DEPARTMENT OF PUBLIC WORKS

ADDENDUM NO. 2
ROBINSON PARK EXPANSION
IN THE CITY OF PASADENA, CALIFORNIA

RE: Revisions to the Plans, Specifications, and Bidder's Proposal

BACKSTOP WITH NETTING

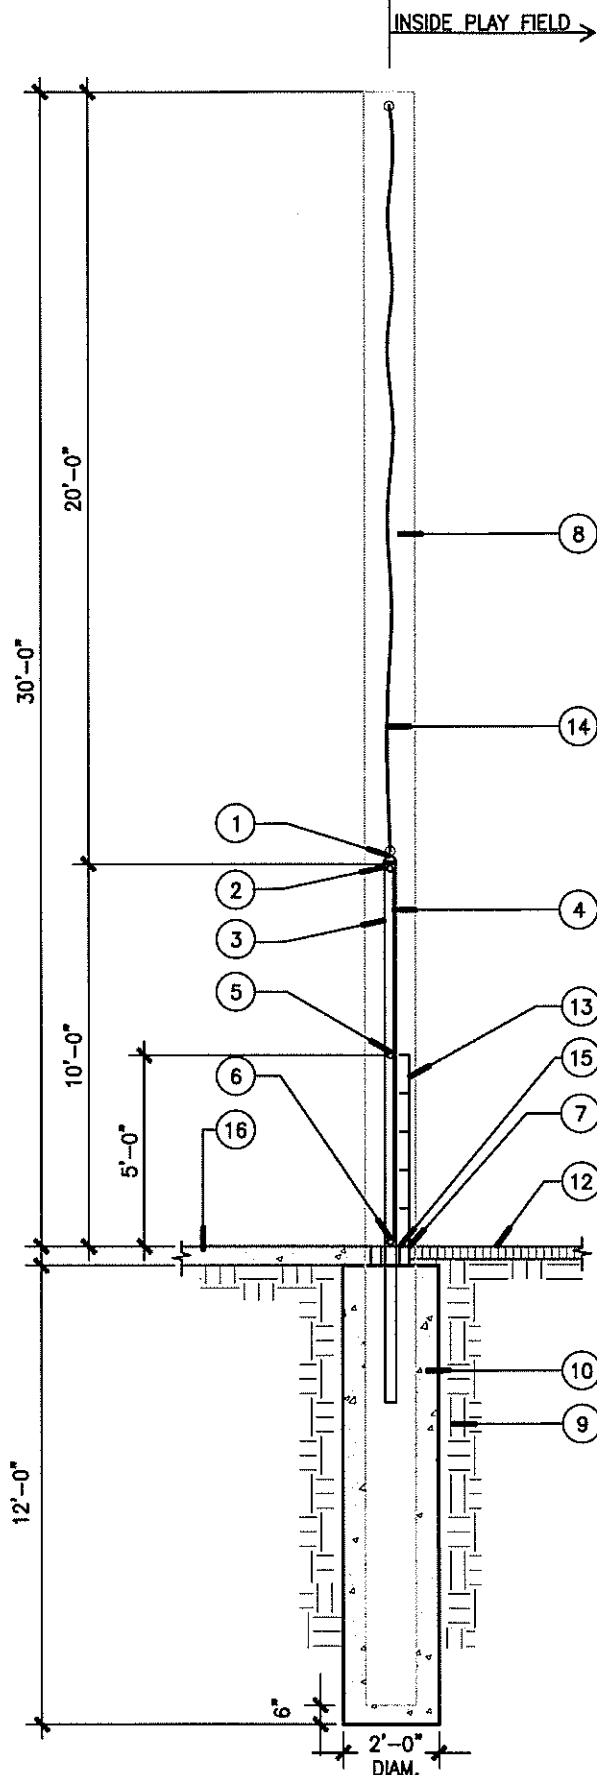
1. Sheet 4 of Drawing No. 5798: Construction Note No. 26 - "Install 15" HDPE Perforated Pipe" shall be deleted.
2. Sheet 19 of Drawing No. 5798: Detail No. 6, Backstop with Netting, is hereby revised, see attached.
3. Sheet 21 of Drawing No. 5798: Details Nos. 1, 2, 3, & 4 – The underlying base materials for the synthetic turf shall be changed from "*crushed miscellaneous base*" to "***permeable stone base***" as specified in Section II-23.01 of the Project Specifications.
4. Sheet 21A of Drawing No. 5798: The materials for all tubular steel fence, guard rails, and gates shall be changed from "5/8" sq. steel pickets" to "***3/4" sq. steel pickets, 14 gauge at 4-1/2" on center.***"

ADDENDUM #2
REVISED 3/19/09
